Draft responses to RAI 385, Questions 09.01.04-15, 09.01.04-16 and 09.01.04-17 are provided in the attached file, "RAI 385 Response Questions 09.01.04-15,-16 & -17 US EPR DC - DRAFT - Part 1 of 4.pdf." The remaining parts will be provided in subsequent e-mails. Earlier today, AREVA submitted Supplement 20 that provided a date for the final responses as August 18, 2011. Please let us know if you have any questions or if we can submit these responses as final.

Subject: DRAFT Response to U.S. EPR Design Certification Application RAI No. 385, FSAR Ch. 9 ,Questions 09.01.04-15,-16 & -17 (Part 4 of 4)
Sent Date: 6/30/2011 8:37:20 PM
Received Date: 6/30/2011 8:38:43 PM
From: WILLIFORD Dennis (AREVA)

Figure 9.1.4-7—Spent Fuel Cask Transfer Facility

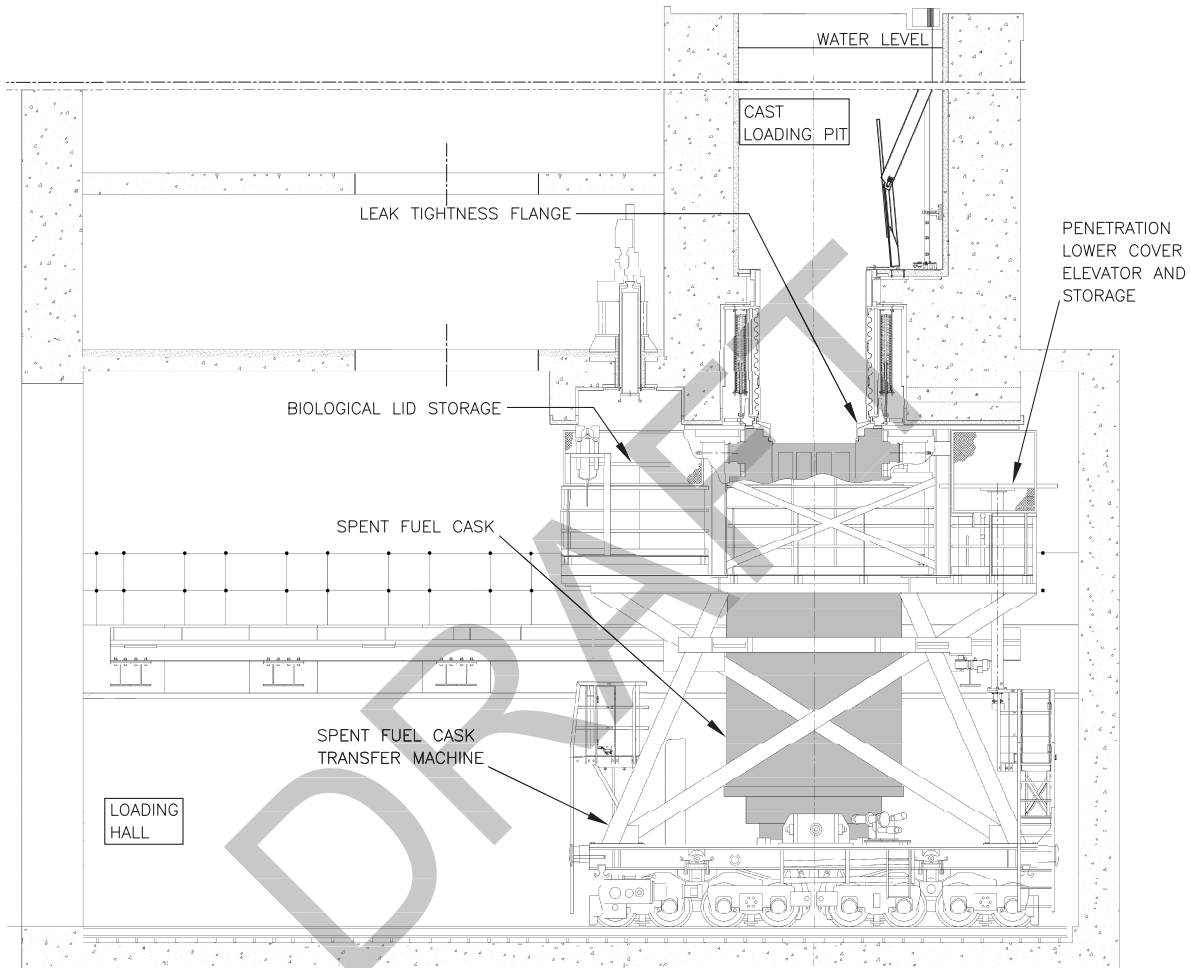
09.01.04-15

Figure 9.1.4-8—Cask Loading Pit Penetration Assembly

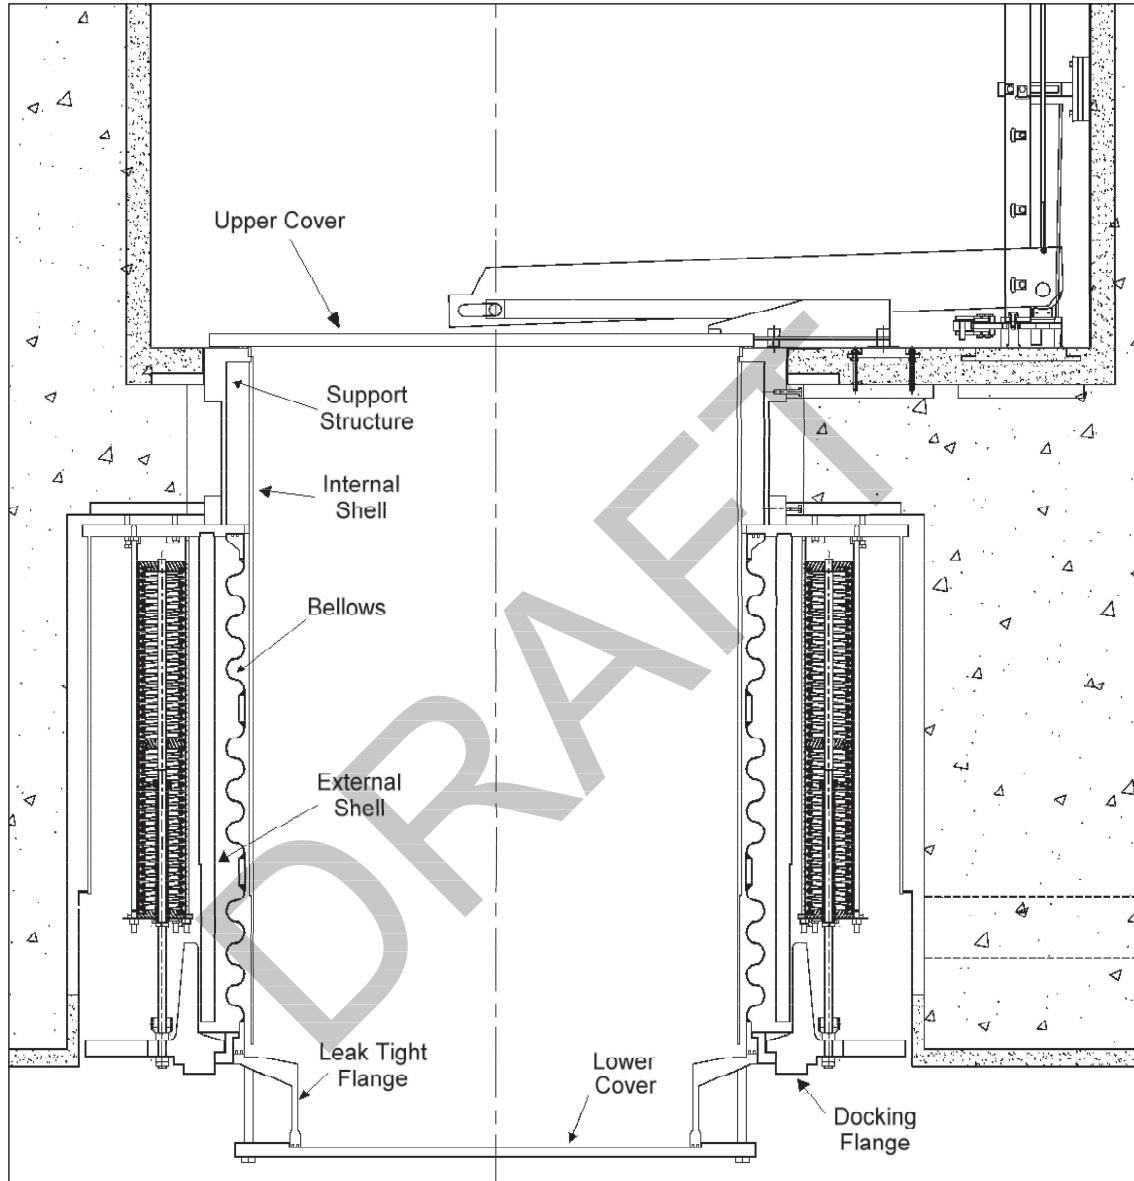
09.01.04-15
